# **M54 to M6 Link Road**

## **TR010054**

### **8.15 Applicant Responses to Documents Received at Deadlines 1 and 2**

November 2020

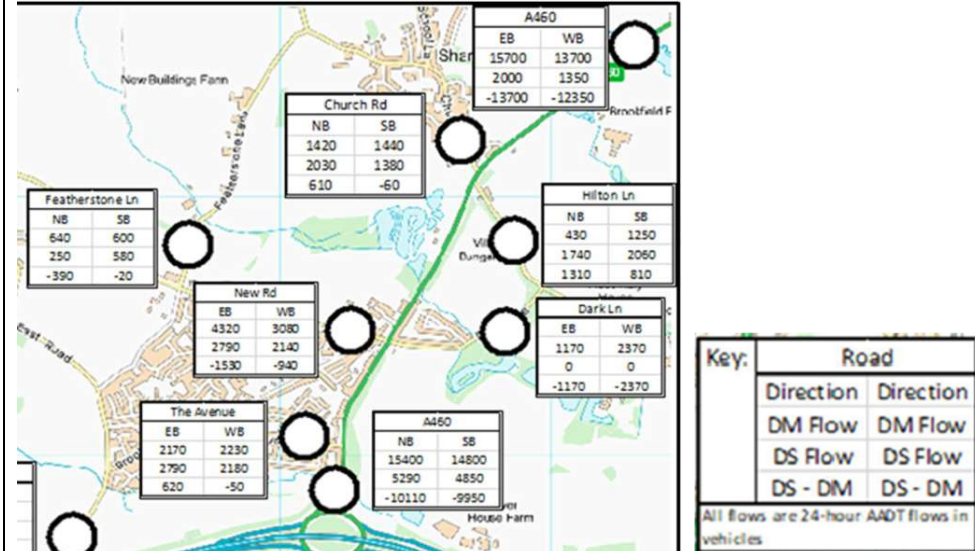
Issue 8a: page 4 para 5 & 6	<p><b>Parking at the southern end of the old A460</b> As a result of the realignment of the old A460 there are areas of the original route that are proposed to be stopped up or the carriageway removed as indicated on STREETS, RIGHTS OF WAY AND ACCESS PLANS REGULATION 5(2)(K) SHEET 4 OF 10. There are two issues here that require further work from HE: 1. Southern section In relation to the southern section of the original alignment that is proposed to become a cul-de-sac as shown on the extract below. There are concerns that given its proximity to the strategic road network this area may become subject to indiscriminate parking. Further measures are considered to be required here to ensure its use is only for residential access and highways maintenance activities.</p>	This item has been discussed further with SCC. The turning head proposed at the end of the cul-de-sac is not designed to accommodate for the turning of HGVs therefore it is anticipated that the likelihood of HGV parking in this area is low as vehicles would be unable to exit without reversing. Furthermore, to discourage 'fly parking' it is anticipated that the existing no waiting restriction will be reinstated along this section of the A460 post completion of the Scheme. Further discussion will be held with the local residents and parish council to address concerns regarding parking at this location and the preferable design solution.

Issue 8b: page 5 para 1	<p><b>2. The area fronting the Petrol filling Station and Public house</b></p>  <p>The area shaded grey in the extract above identifies the length of the A460's original alignment that HE proposes to remove the carriageway but retain the area as public highway. Our understanding is the rationale for this is down to the presence of utilities in the highway and the cost of diversion. We have several issues with this approach and the uncertainty created. Starting with the access to the public house as annotated above. The pub seems to have two access points to its car park whilst the southern access is broadly unaffected the northern access appears to be made redundant by the proposal but the property would still front publicly adopted highway at this location.</p> <p>The scheme proposed two new access drives to the Petrol filling station and surrounding uses from the realigned road. The southernmost access drive crosses an area of land shaded white (or unshaded), this land is to be permanently acquired by HE to deliver the scheme. Effectively, as this land is not part of the highway the access drive therefore crosses third party between the new road alignment and the old alignment. Where the access drive sits above the old alignment of the A460 it will be subject to all legislation covering the adopted public highway and would be subject to maintenance at public expense. Similar issues exist for the northern access.</p> <p>In addition the old A460 alignment as public highway would be usable by the public, which may create confusion for frontage owners.</p> <p>There is no clarity on what is proposed for the area between the new highway and old alignment or who will be responsible for it. Further on the ground it will be difficult to define areas that are public highway from areas that are in other ownership. We believe the old alignment of the A460 shaded grey in the extract</p>	<p>This item has been discussed further with SCC. Further information regarding the highway boundary and maintenance liability for the area has been provided to SCC, however there are still concerns around the additional maintenance requirements that this would impose on the local highways authority. Highways England will continue to liaise with SCC on this matter alongside discussions with the Parish Council regarding the potential for maintenance to be managed locally.</p>
